SERVICE BULLETIN

DATE: 26 SEPTEMBER 1994
PAGE 1 OF 6

FIREWALL FUEL FITTING MODIFICATION

Figure 1. Firewall Fuel Fitting Modification (Installation).

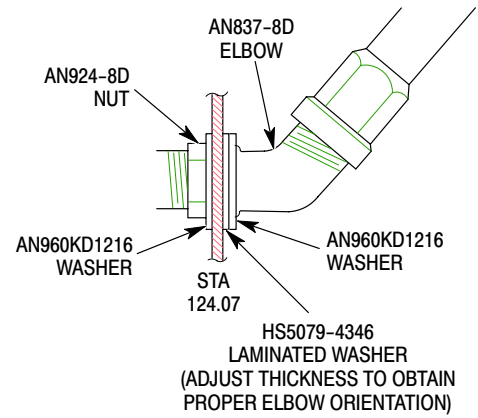
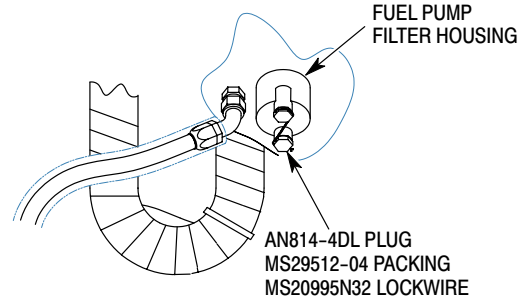
MDHI has received reports from the field of the station 124 firewall fuel fitting interfering with the landing gear brace. As a result, there is a possibility of the fuel fitting becoming damaged, thus creating a potential for fuel leakage. Therefore, MDHI is requiring all operators to modify their aircraft according to procedures contained in this Notice.

Operators are required to install an AN837-8D elbow at station 124.00 and remove the drain valve from the engine fuel pump filter housing.

- (3). Install AN924-8D (nut), (2) AN960KD1216 (washers), HS5079-4346 (laminated washer) and AN837-8D (elbow) as shown in Figure 1.
- (4). Ensure that AN837-8D is clocked 12° to 16° (25° to 29° for fuel systems equipped with anti-ice fuel filter installations) inboard as shown in Figure 1.

NOTE: HS5079-4346 shim thickness may be adjusted to obtain proper elbow orientation.

- (5). Reassemble fuel cell lacing per the HMI Vol. I, Section 28-00-00.
- (6). Re-install hoses to the AN837-8D fitting (see Figure 1). Torque hoses per the HMI-CSP-2, Vol. I, Section 28-00-00.

- (7). Install AN814-4DL plug, MS29512-04 packing and MS20995N32 lockwire to engine fuel pump housing 369A8100-507 configurations only at location shown in Figure 1.
- (8). Re-fuel aircraft per servicing instructions contained in the Handbook of Maintenance Instructions (HMI).

NOTE:
A/C EQUIPPED WITH ANTI-ICE FUEL FILTER INSTALLATIONS MUST CLOCK THE FITTING TO 25° - 29°.

Figure 2. Firewall Fuel Fitting Modification (Removal).

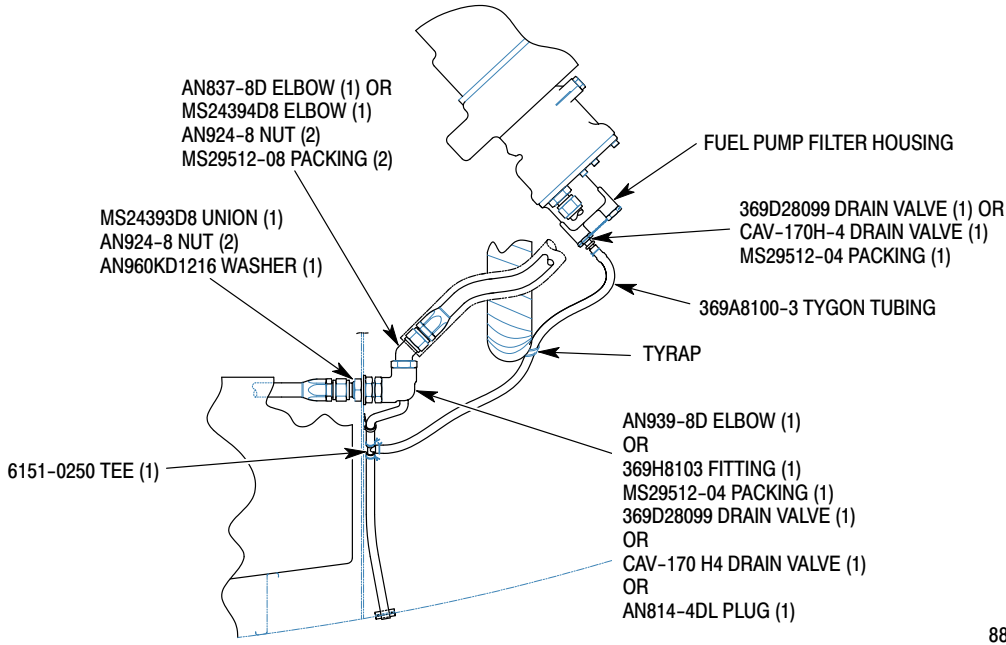
- (1). Refer to HMI Vol. I, Section 28-00-00 for access to fittings. This will require loosening the lacing supporting the fuel cell.
- (2). **If installed**, remove the following parts from the 369A8100-503, -505, -507, -509, -511, -703 and -705 fuel system installations: (see Figure 2)

MS24393D8	union, qty. 1
AN924-8	nut, qty.3
MS29512-08	packing, qty.2
369H8103	fitting, qty. 1
369D28099	drain valve, qty. 1 or 2
CAV-170-H4	drain valve, qty. 1 or 2
369A8010-85	tygon tubing
MS29512-04	packing, qty. 1 or 2
TY-25M	ty-rap
369A8100-3	tygon tubing
369A8100-5	tygon tubing
369A8100-7	tygon tubing
AN837-8D	elbow, qty. 1
MS24394D8	elbow, qty. 1
AN814-4DL	plug, qty. 1
AN939-8D	elbow, qty. 1
6151-0250	tee, qty. 1
